HISTORIC AND DESIGN REVIEW COMMISSION

HDRC CASE NO: 2021-509
ADDRESS: 911 N PINE ST
LEGAL DESCRIPTION: NCB 531 (PINE AT HAYS {IDZ}), BLOCK 13 LOT 25
ZONING: IDZ, H
CITY COUNCIL DIST.: 2
DISTRICT: Dignowity Hill Historic District
APPLICANT: Llyas Salahud-din
OWNER: SA URBAN HOMES LLC
TYPE OF WORK: Addition of staircase, amendment to previously approved carport, extension of previously approved deck
APPLICATION RECEIVED: October 26, 2021
60-DAY REVIEW: Not applicable due to City Council Emergency Orders
CASE MANAGER: Edward Hall

Historic and Design Review Commission
Design Review Committee Report

HDRC Case #: 2021-509

SITE
FIRST FLOOR
SCALE:
 $3/16" = 1' - 0"$
11.4.21
2x2 True Grid

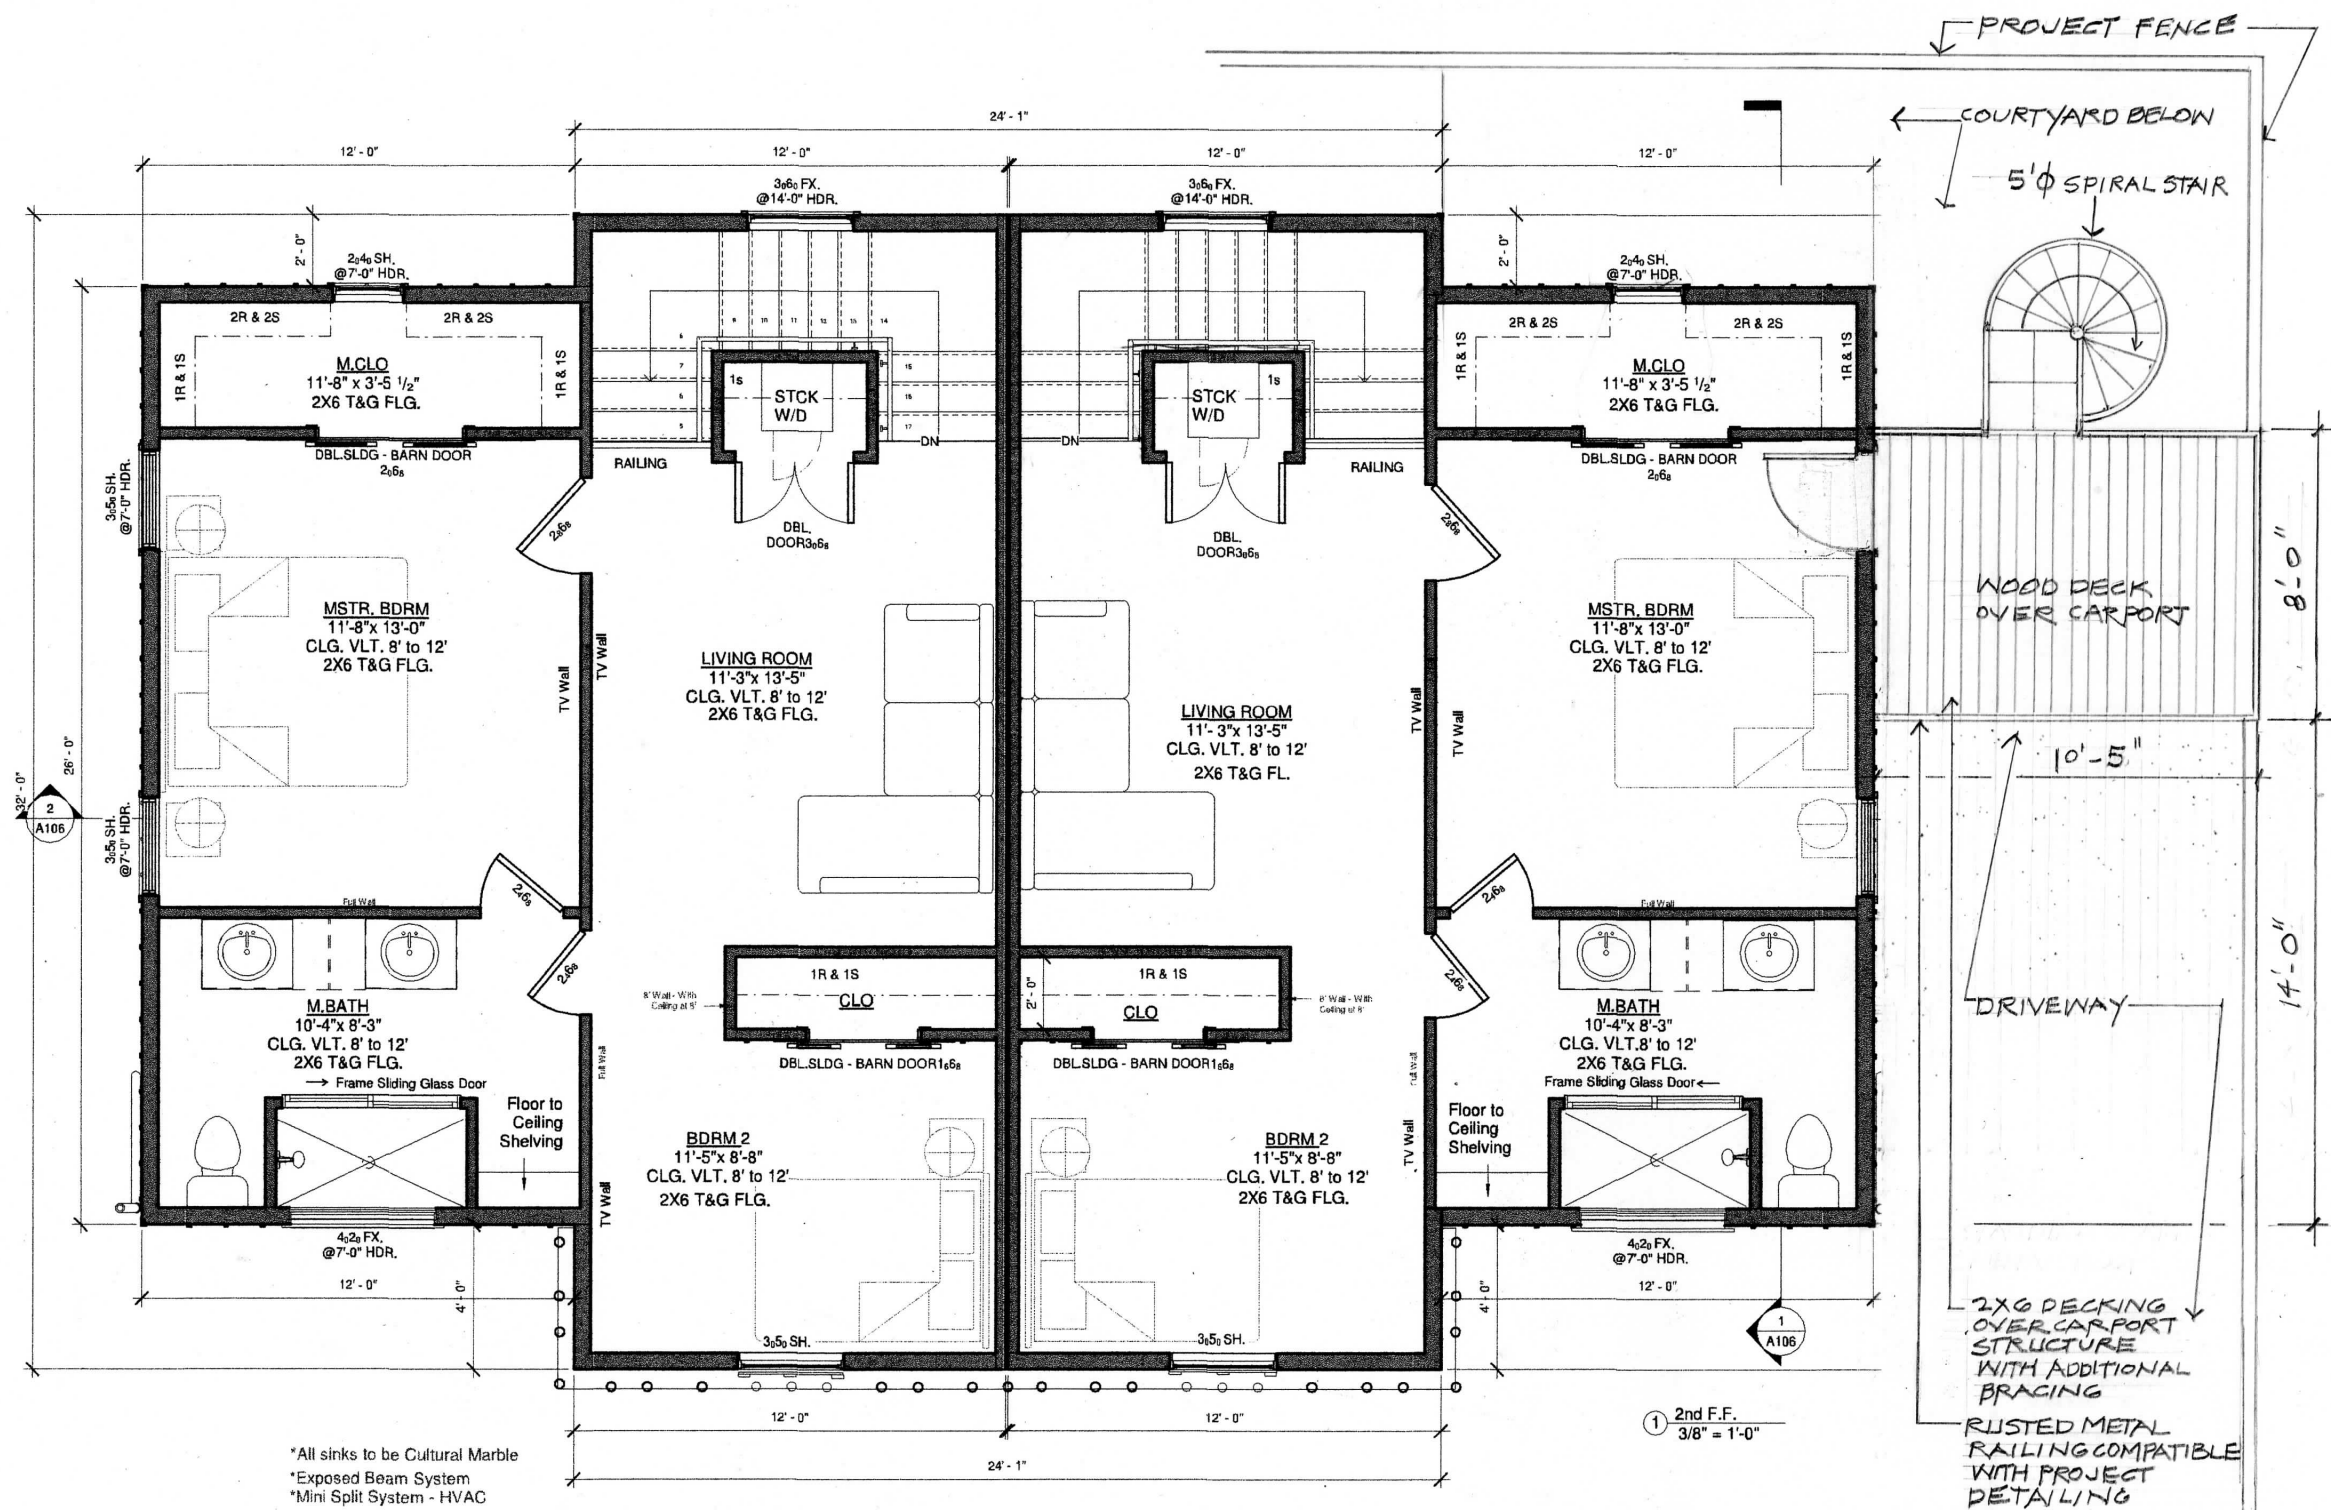
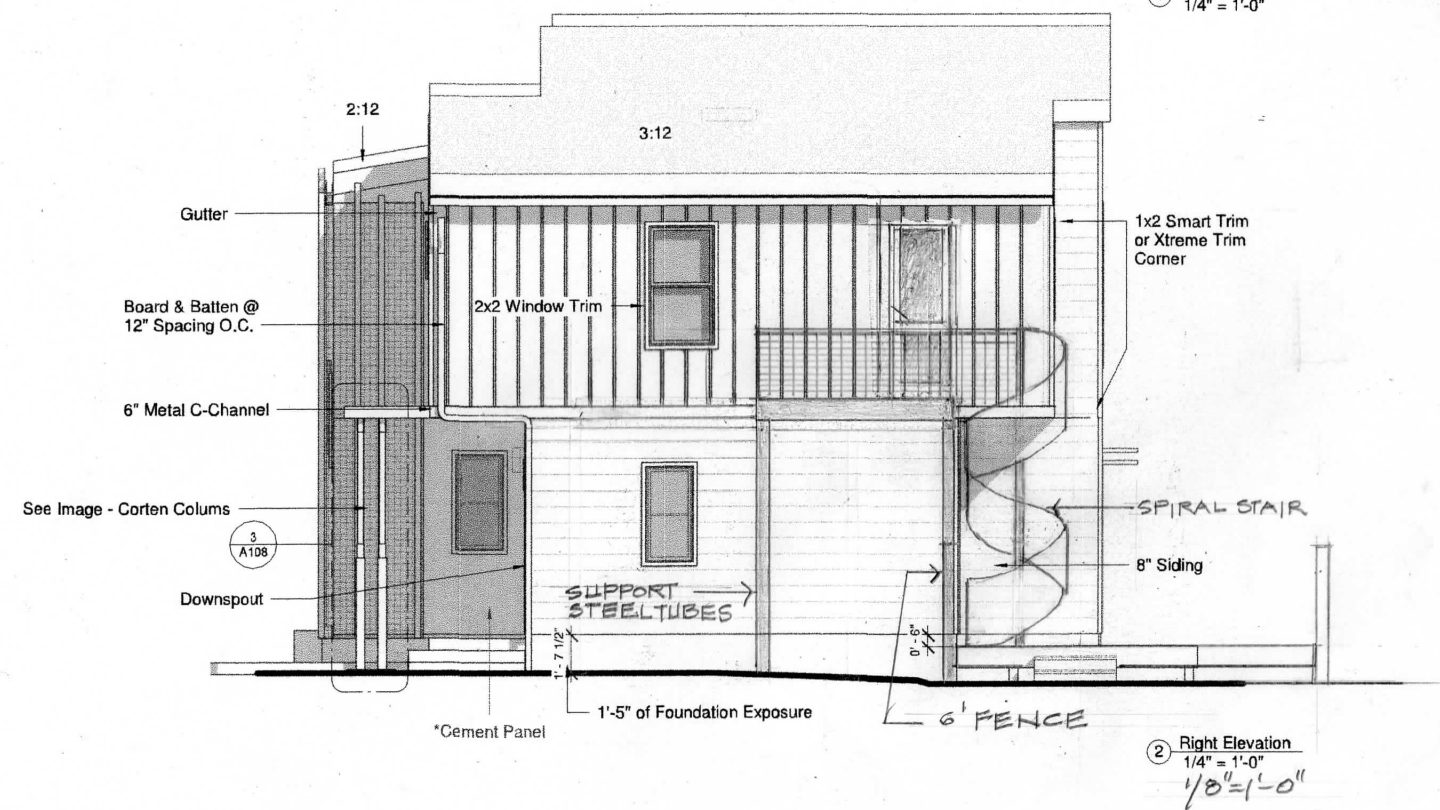
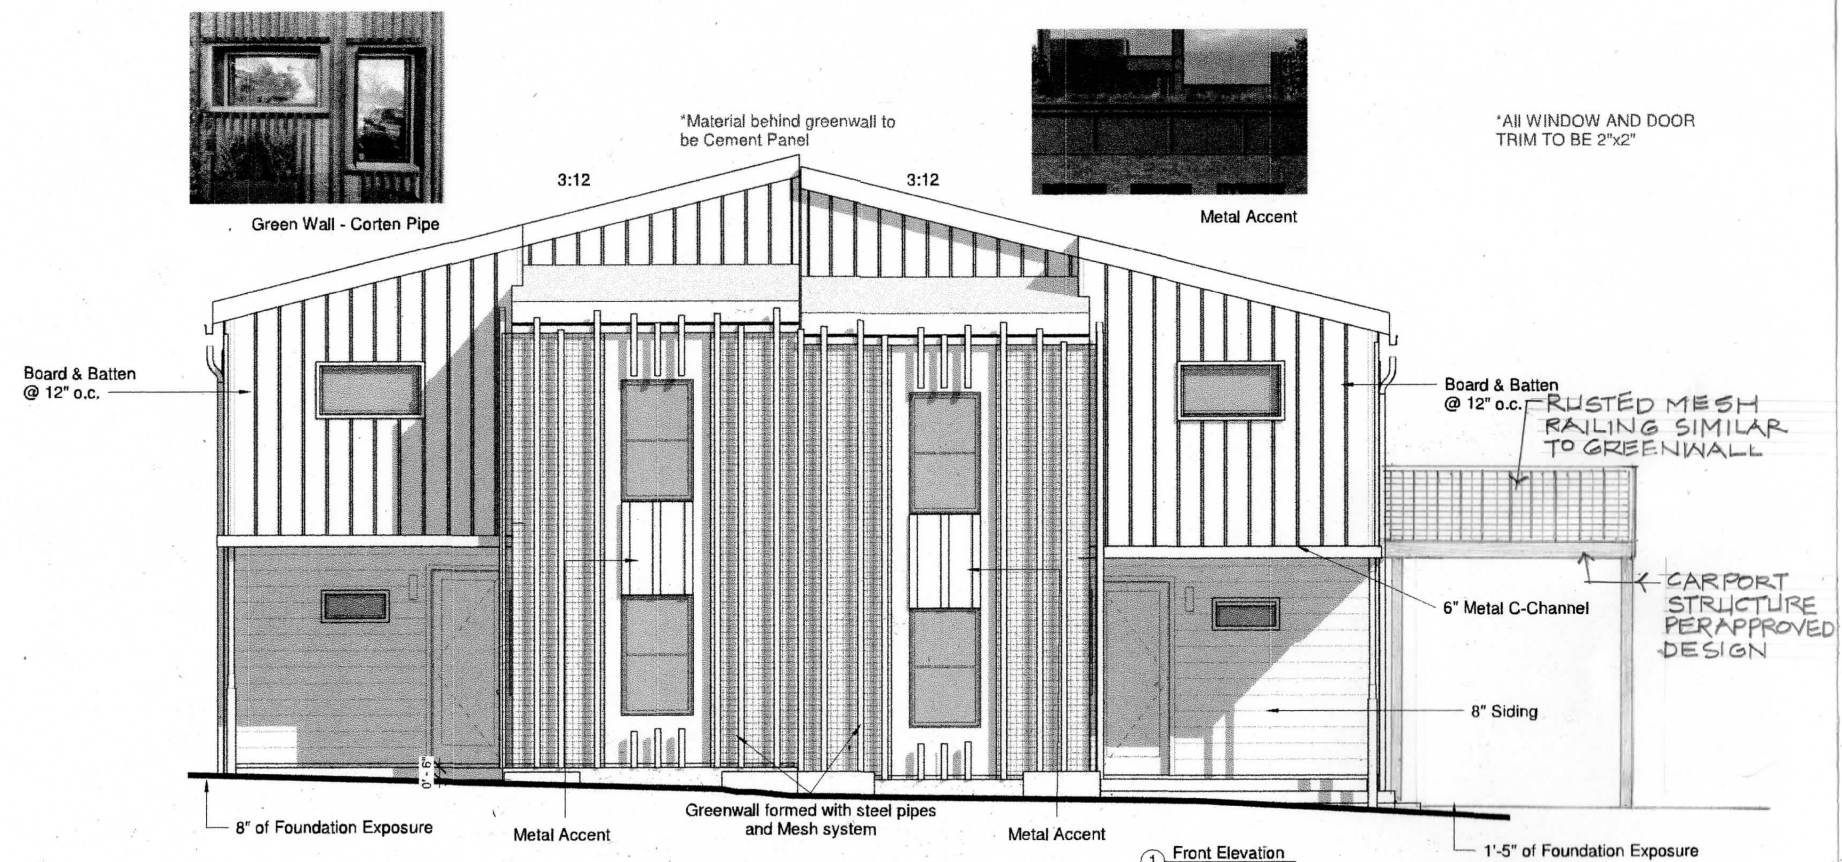
MS: Primary concern was regarding the ground level deck.

MS: Consider moving the staircase closer to the rear corner of the house.

MS: Study how to relocate the stair without constructing the second level deck.

JF: Generally okay with location of stair and deck where located.
